**Re: Request for Council's Advice on SSD-77211717 – Edmondson Park Block 24  
Affordable Housing**

## Attachment A – Detailed comments

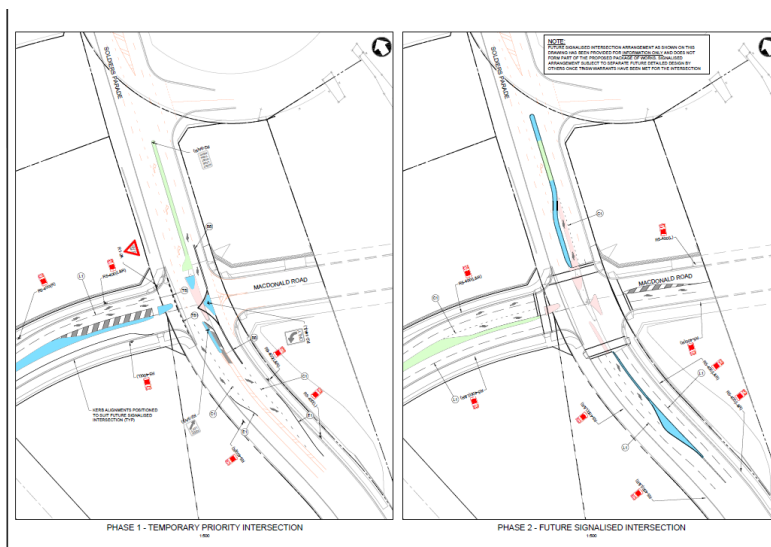
Interim on-site water quality treatment facilities must be implemented to ensure that stormwater runoff from the site complies with Council's water quality standards, as outlined in the civil engineering report prepared by Xavier Knight Pty Ltd (Reference: Project Number 240601, Civil Engineering SSDA Report – Lot 303 Croatia Avenue, Edmondson Park, Issue D, dated 2 April 2025). These facilities must be designed using MUSIC modelling software, with performance verified through Council's MUSIC Link tool. The interim water quality treatment measures must remain in place until the construction of Raingardens D13 is completed.
